ALERT SERVICE BULLETIN

SB No.: 01/24 - Initial Issue
Title: Incorrect webbing on Occupant's Restraint Harness

Issue Date: 16 April 2024
Publication Ref. 218

Figure 1

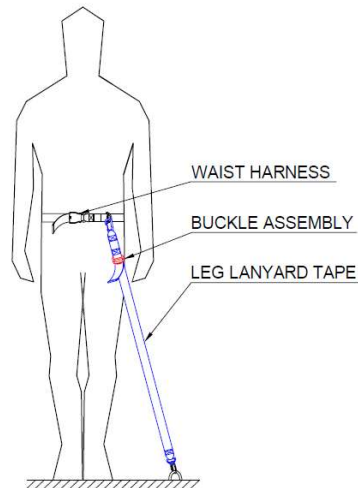
CI-C-1302 Occupant's restraint harnesses where the safety tape has been incorrectly routed/sewn to the adjustment Buckle of the Leg Lanyard (See Figure 1 & Appendix 1)

Description of the restraint harness elements involved (marked blue and red)

A number of restraint harnesses have been identified to mount the buckle for leg lanyard length adjustment in an incorrect way, where the safety tape used has been routed and sewn so that the buckle is not acting in the expected position. As a result, the nominal friction applied by the buckle to the tape is reduced, and the assembly may suffer an unexpected extension when loaded.

- 1) Ultramagic must be contacted, preferably using the form in Appendix 4 of this SB.
- 2) The leg lanyard tape of all affected harnesses must be **identified** and **replaced** with P/N CI-C-1308. This must take place **prior to the next flight** unless action (3) below is adopted.

Such replacement consists in the removal of the lanyard tape by undoing the quick link securing the tape to the restraint attachment point and installing the replacement harness (CI-C-1308) instead. Quick link must then be closed with a 9mm spanner, preferably adding first a drop of Loctite® 638 to the fillet.

Example of a correct VS incorrect assembly

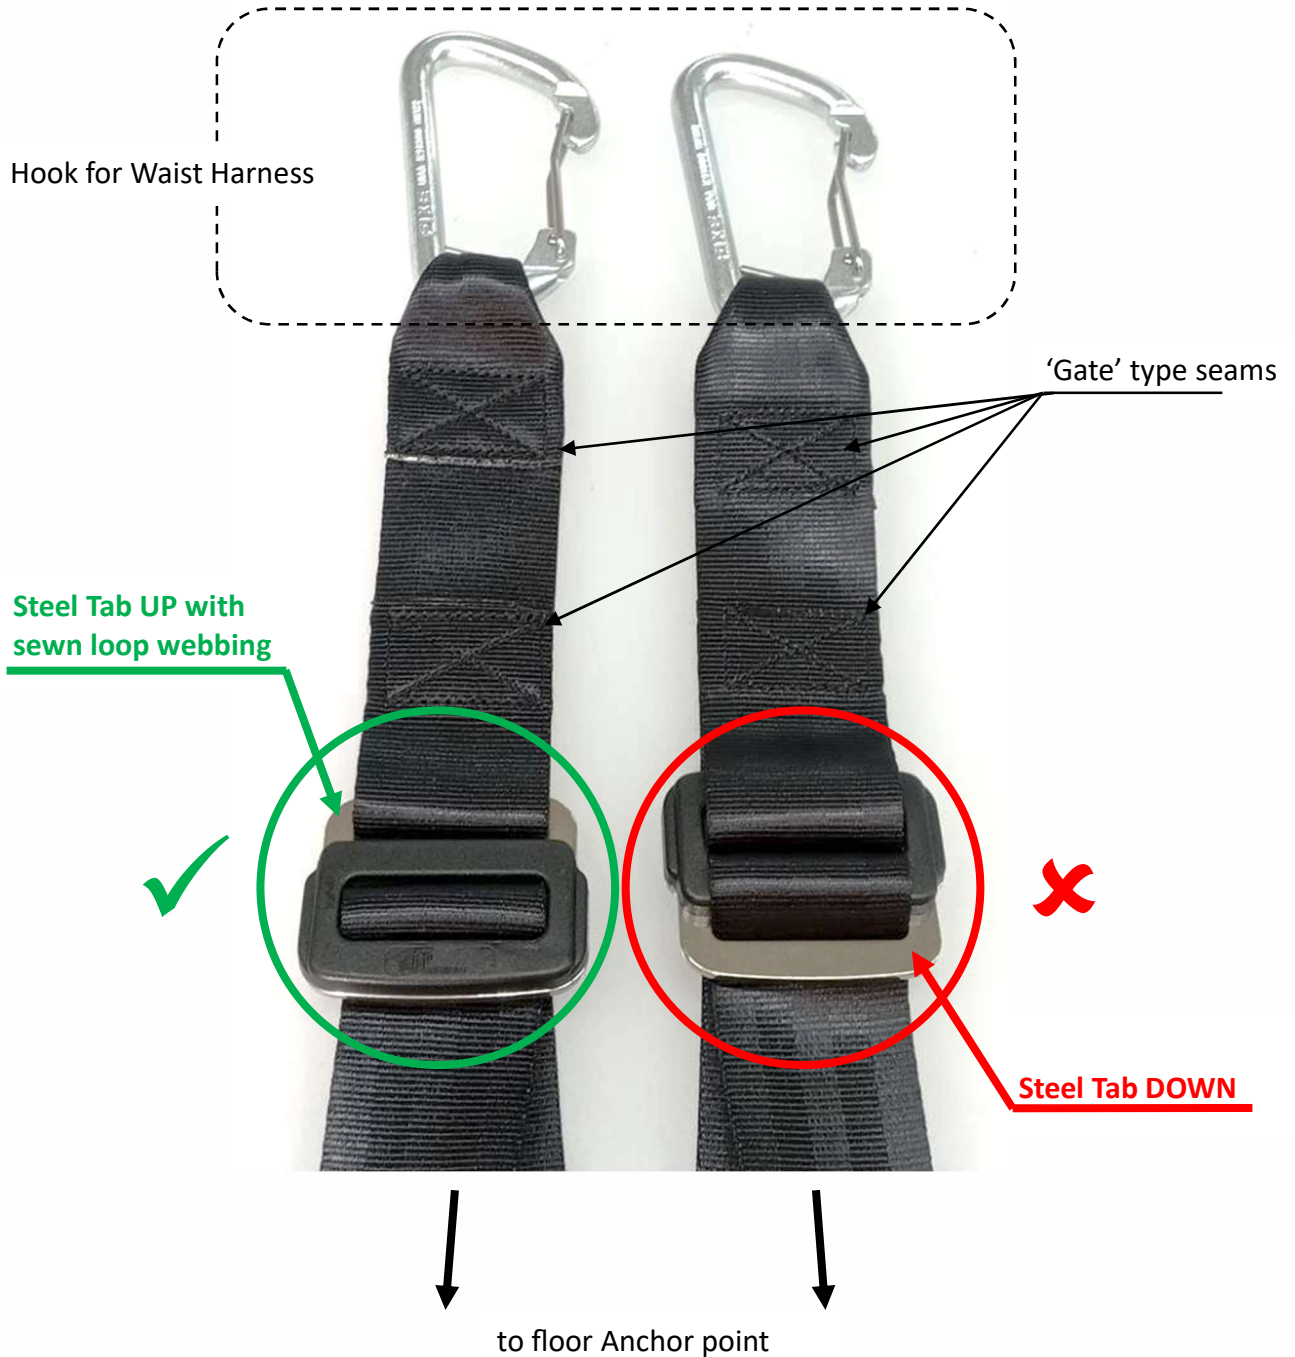
APPENDIX 1 to SB01/24
